RHODE ISLAND DEPARTMENT OF TRANSPORTATION

Rt 5 - Lambert Lind Hwy C-1 (Mayfield Ave - I-95)

NOTICE TO PROSPECTIVE BIDDERS

ADDENDUM NO. 1 Prospective bidders and all concerned are hereby notified of the following changes in the Plans, Specifications, Proposal and Distribution of Quantities for this contract. These changes shall be incorporated in the Plans, Specifications, Proposal and Distribution of Quantities, and shall become an integral part of the Contract Documents.

DRAINAGE DETAILS - 4

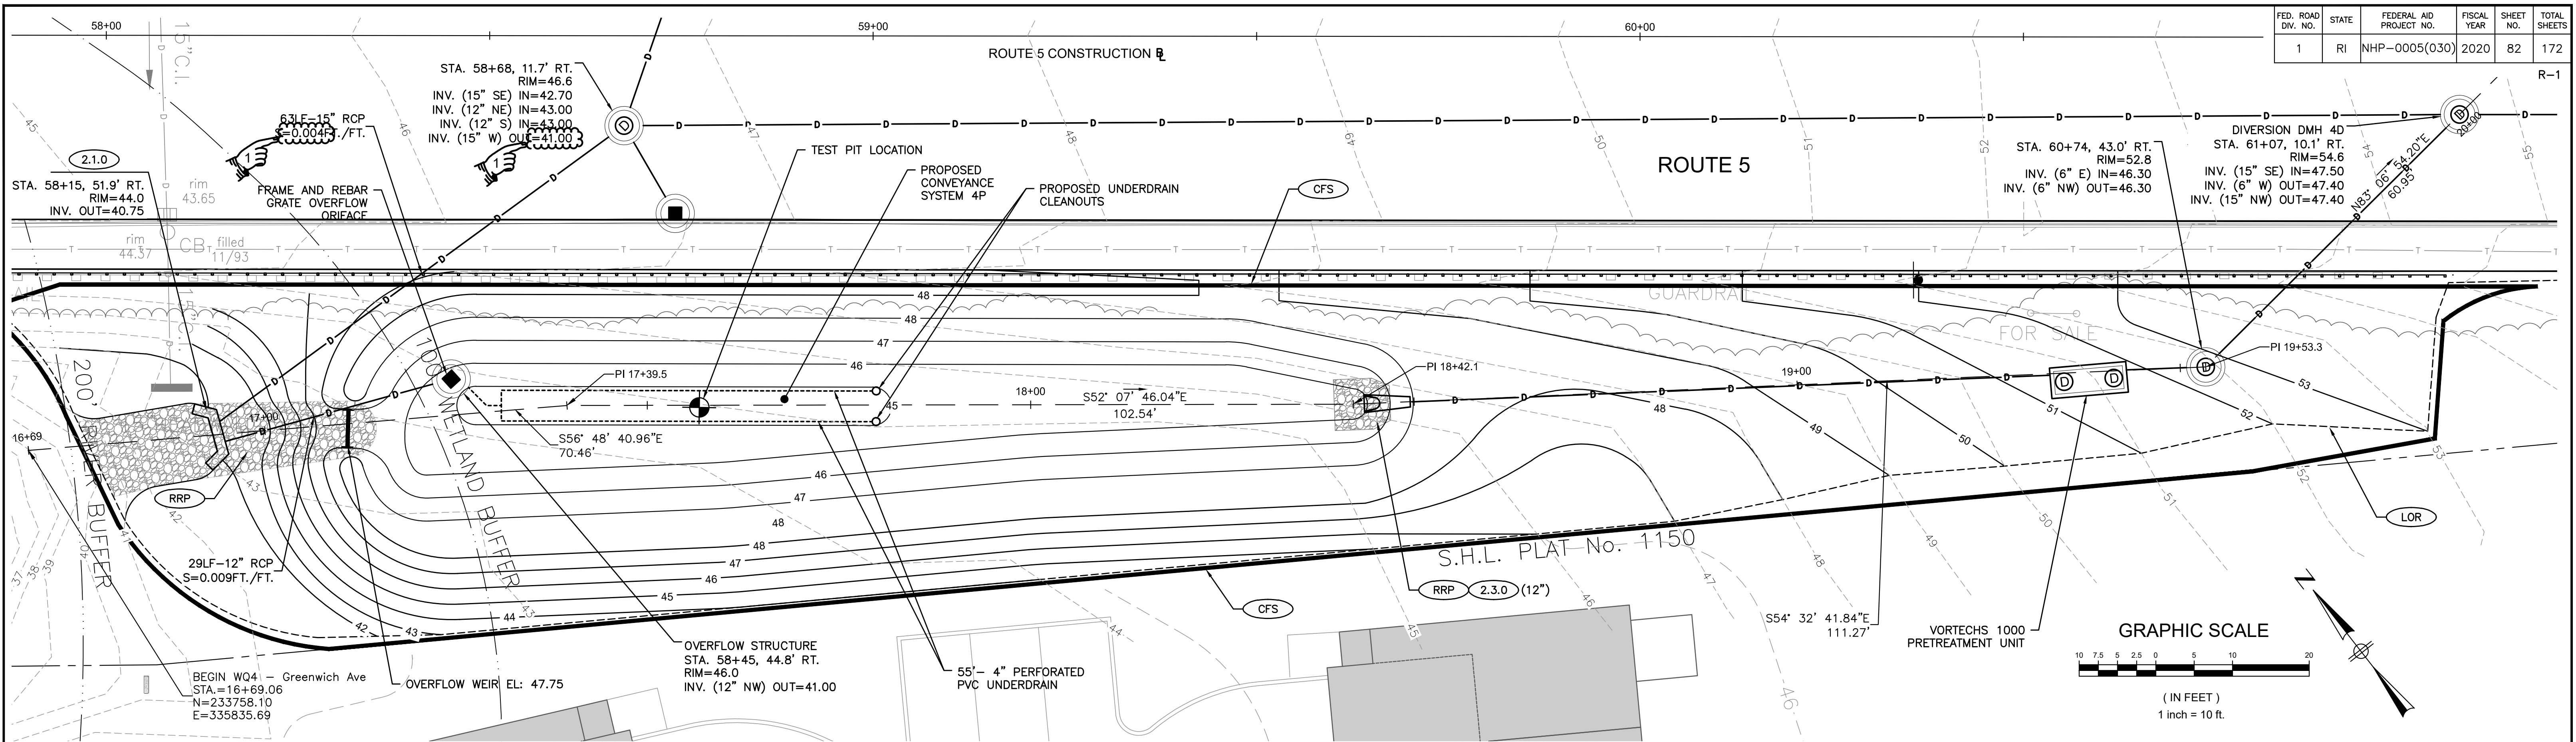
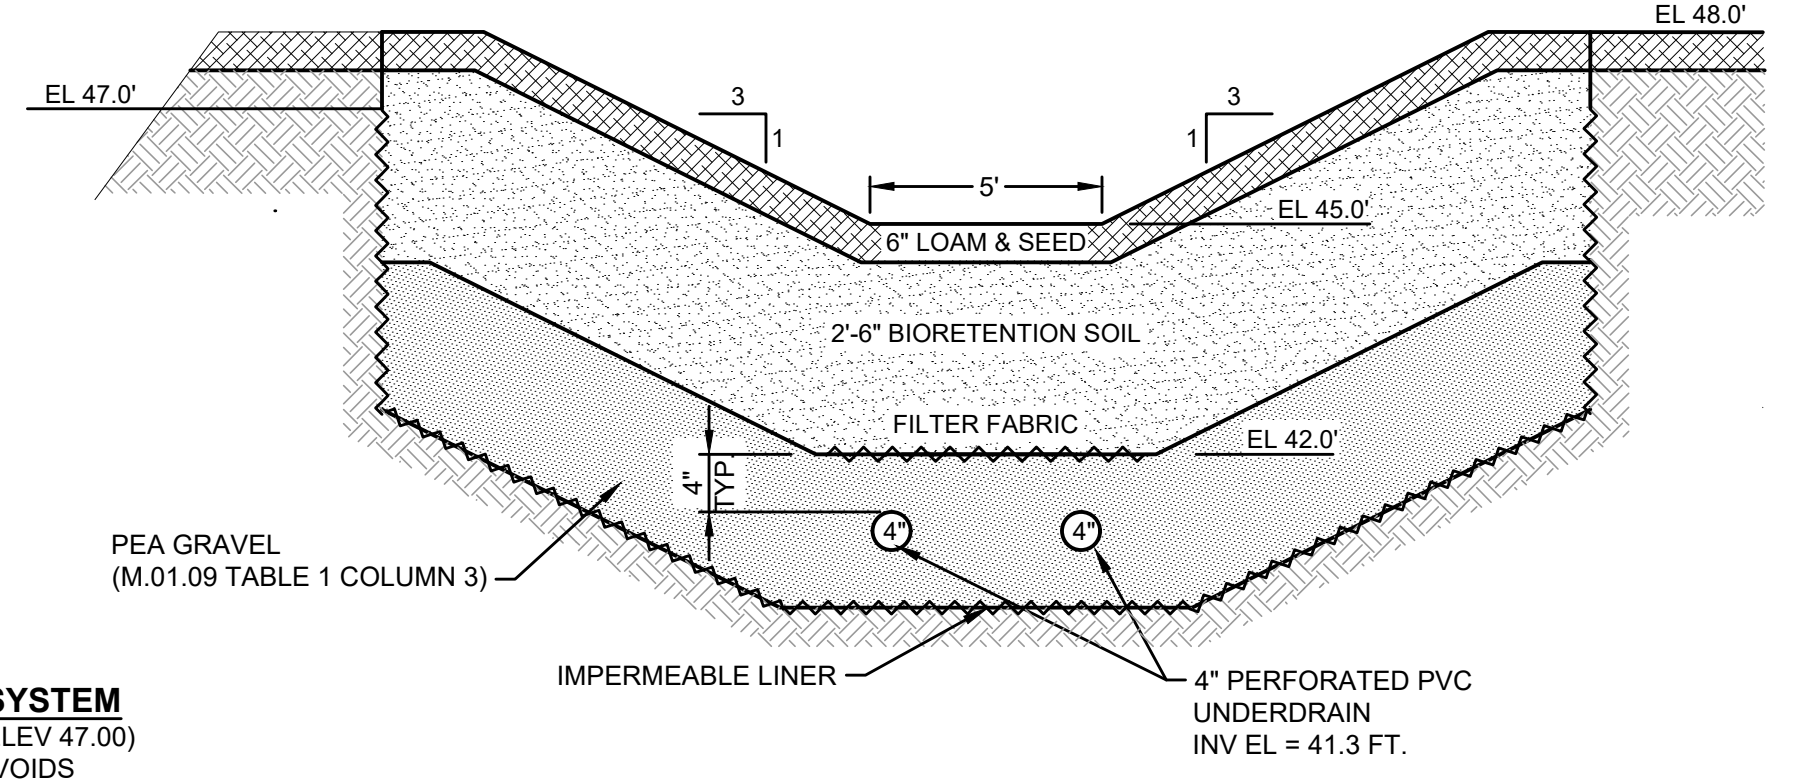
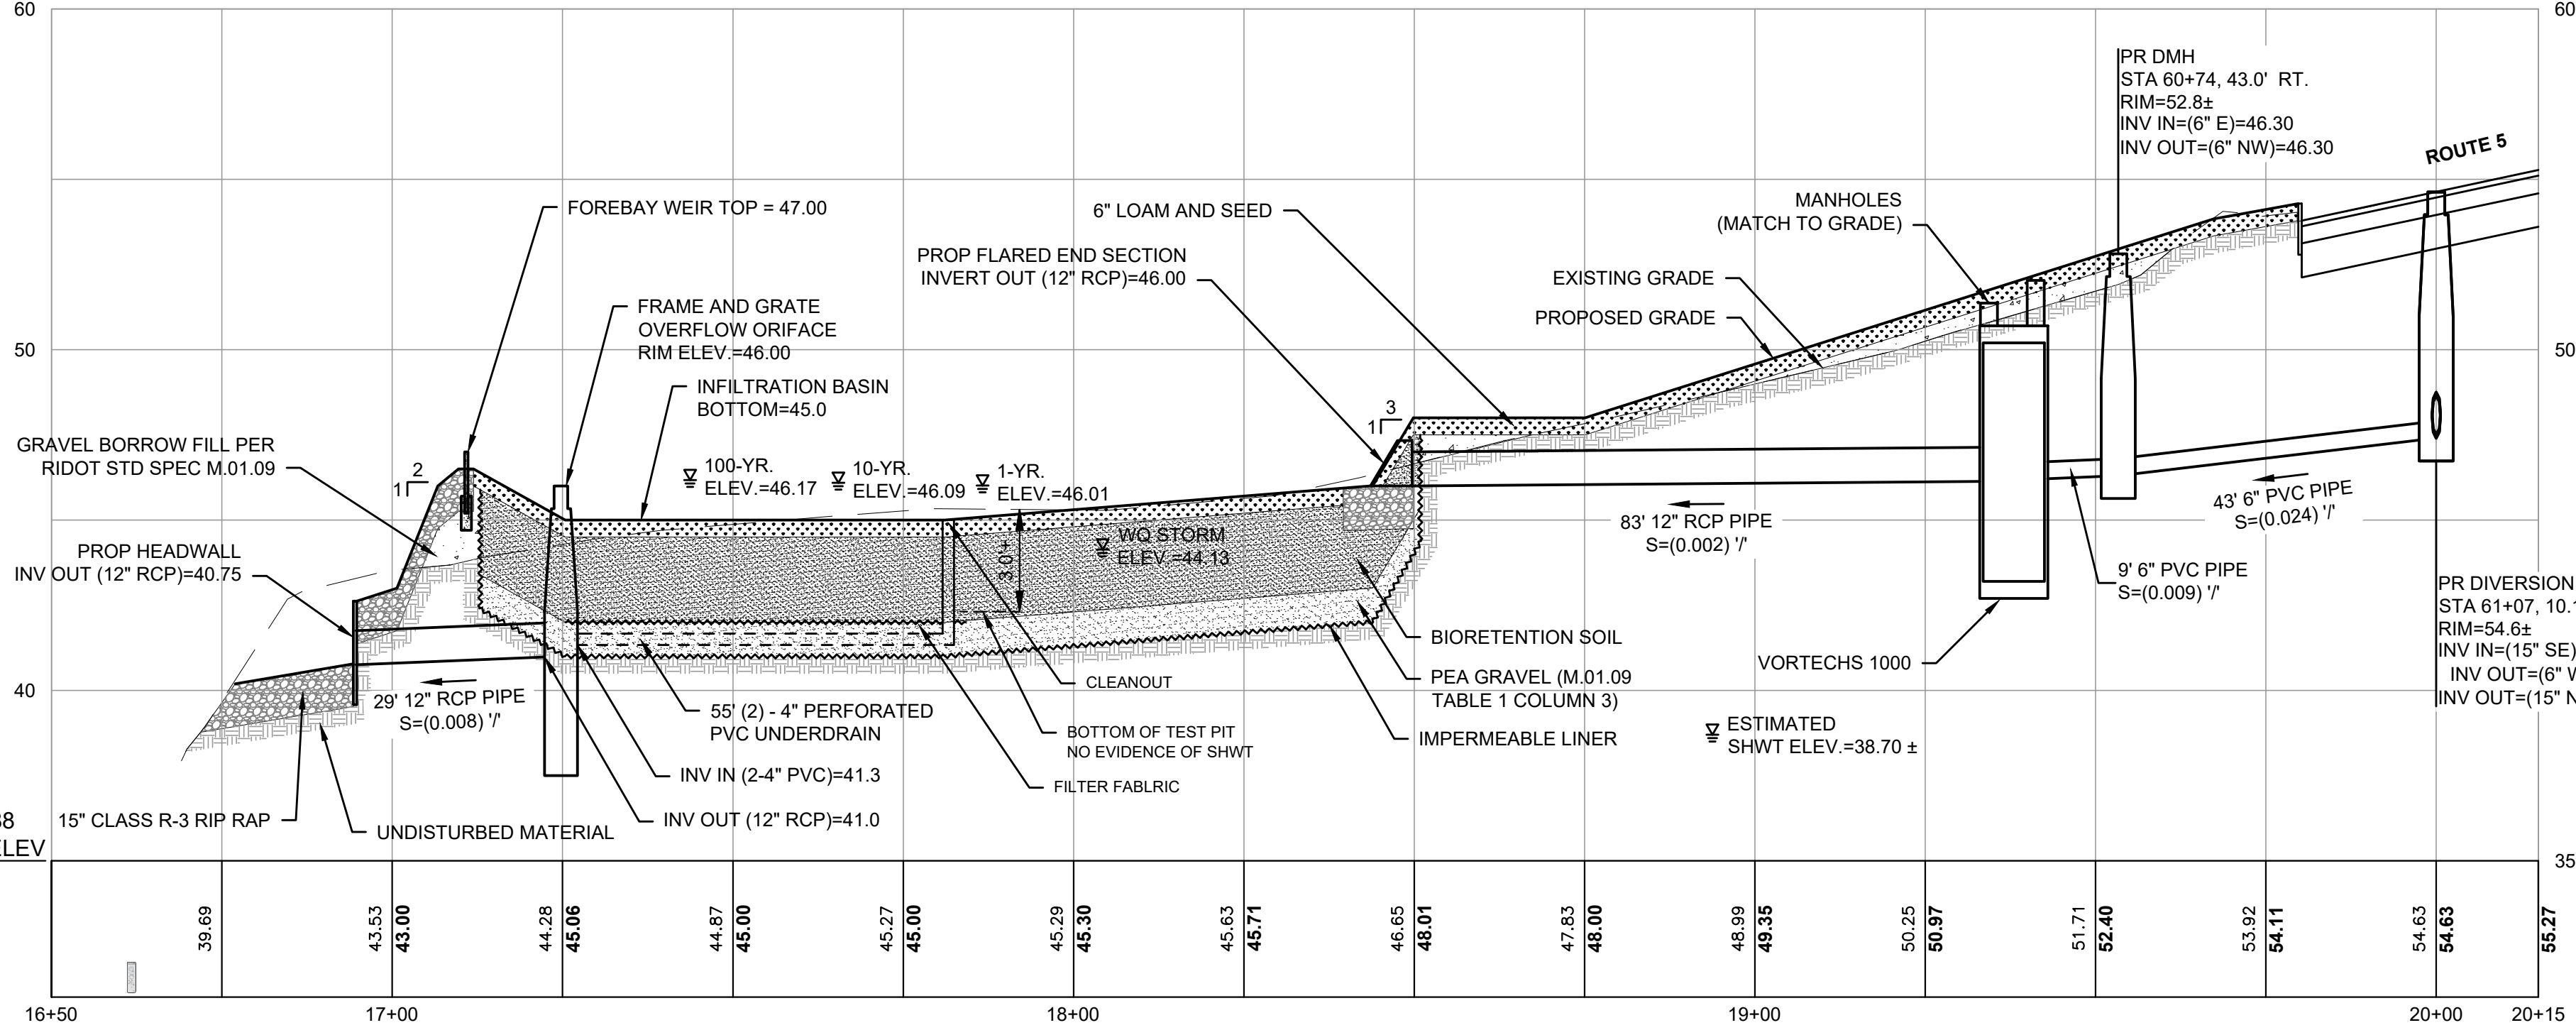
NOTES
 1. ALL WORK ASSOCIATED WITH WATER QUALITY BASIN 4 INCLUDING ASSOCIATED LANDSCAPING SHALL BE INSTALLED AND COMPLETED BY OCTOBER 15, 2020.
